Submission in Response to SSD Application – 29 Florida Street, Sylvania

**SSD Reference:** SSD-83258708

**Applicant:** Homes NSW

**Property:** 29 Florida Street, Sylvania NSW

### **Attachment A**

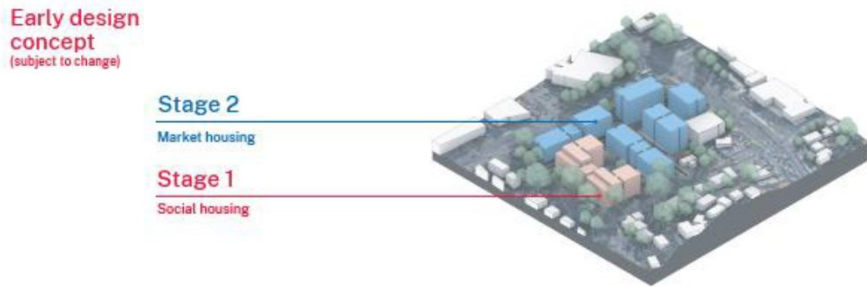
Modest scale of the property which starts below street level. The impact of a 9 storey structure immediately behind/beside this property has not adequately been addressed.

SITE CONTEXT & ANALYSIS  
2.5 SITE ANALYSIS & KEY CONSTRAINTS

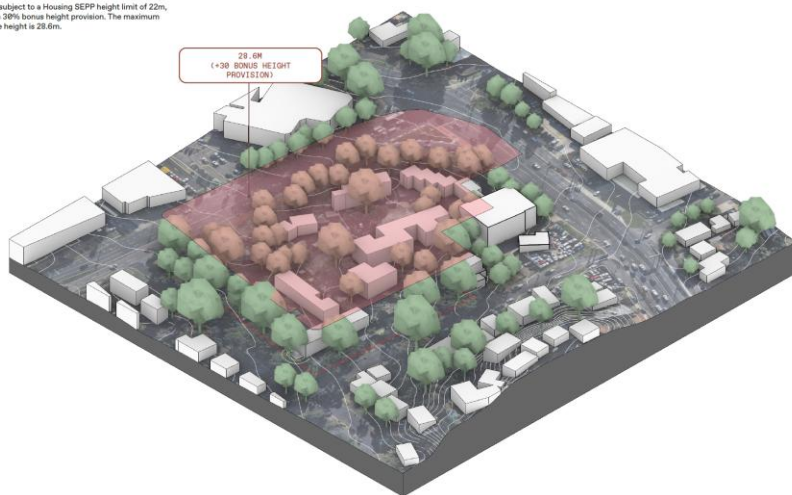
- ii) Design Report showing severely obscured view of property at 27 Florida St (neighbouring property) as provided in 'Appendix E'. The duplex at 27 Florida St is grey and **mostly obscured** by a tree. This deliberately distorts the real impact on the immediately neighbouring property.

- Revised and transparent visual impact material that accurately depicts the existing two-storey building at 27 Florida Street in the same manner as other neighbouring properties (not greyed out, obscured or missing) and does not rely on speculative future landscaping to downplay impacts.
- A reassessment of parking, servicing, and traffic impacts that reflects local car dependence and avoids overspill impacts on surrounding residential streets.
- Strict and enforceable construction conditions, including conservative hours, real-time monitoring at the boundary of 27 Florida Street, and clear mechanisms for managing exceedances and complaints.
